# SAM D21 Family

## SAM D21 Family Silicon Errata and Data Sheet Clarification

The SAM D21 family of devices that you have received conform functionally to the current Device Data Sheet (DS40001882D), except for the anomalies described in this document.

### 2.3 Schematic Checklist - Crystal Oscillator (Chapter 42 of the Device Data Sheet)

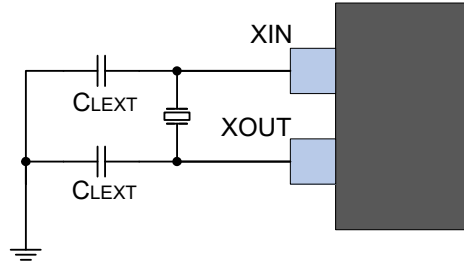
The load capacitor values shown in figure 42-6 and table 42-5 should not be used.  $C_{LEXT}$  should be calculated from the Load Capacitance Equation listed below. The corrected information is shown in **BOLD** type.

**Table 2-1. Crystal Oscillator Checklist**

Signal Name	Recommended Pin Connection	Description
XIN	Load capacitor $C_{LEXT}^{(1)(2)}$	External crystal between 0.4 to 30 MHz
XOUT	Load capacitor $C_{LEXT}^{(1)(2)}$
